Meeting Agenda

Franklin Municipal Planning Commission

Thursday, February 27, 2020 | **7:00 PM** | **Board Room**

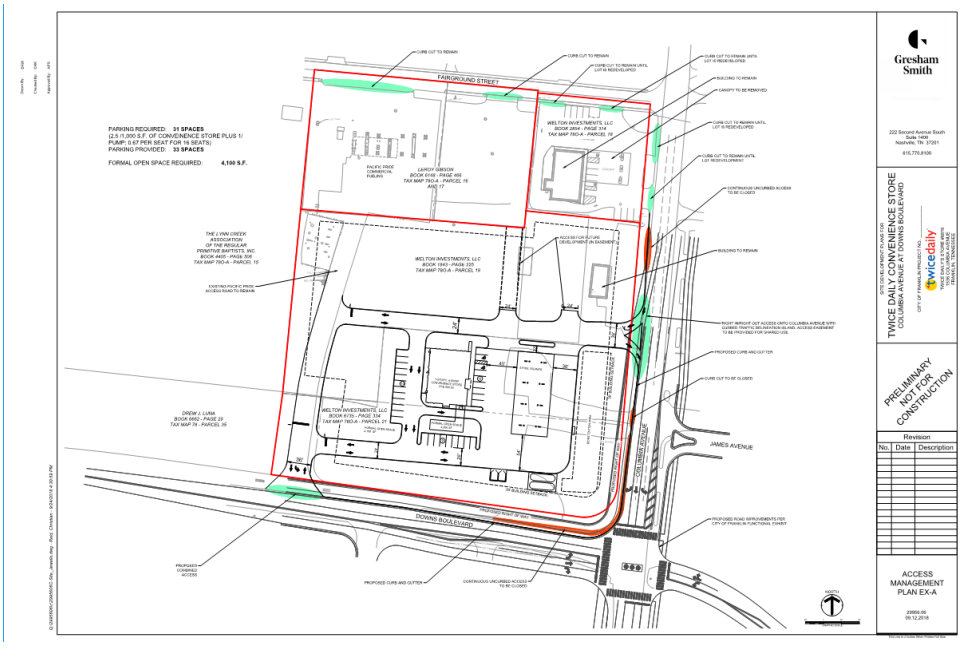
Any access to the redeveloped lots should be defined by the showing of physical improvements (curbing, pavement, etc) rather than notes which are easily overlooked. Any access to the reconfigured lots shall be per the previous agreement and Access Management Plan Ex-A as uploaded below.

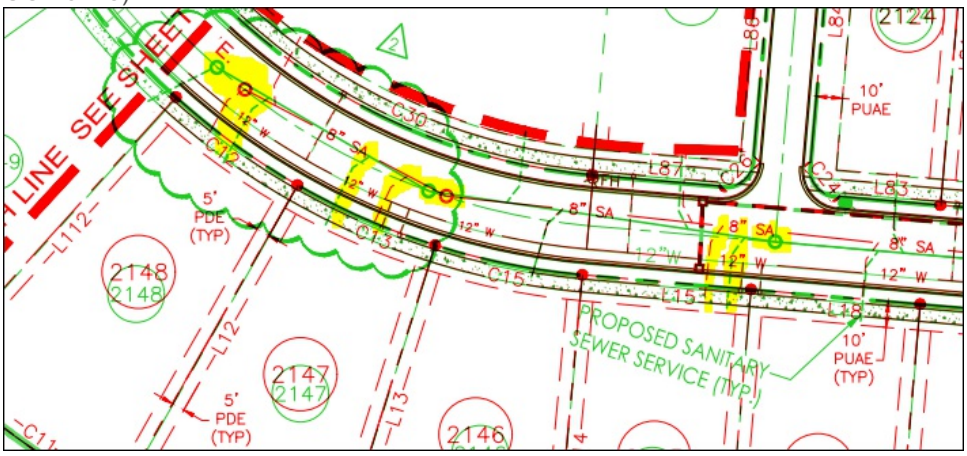
See overlay example below. (Red - Submitted Final Plat; Green - Approved Site Plan COF 6748)
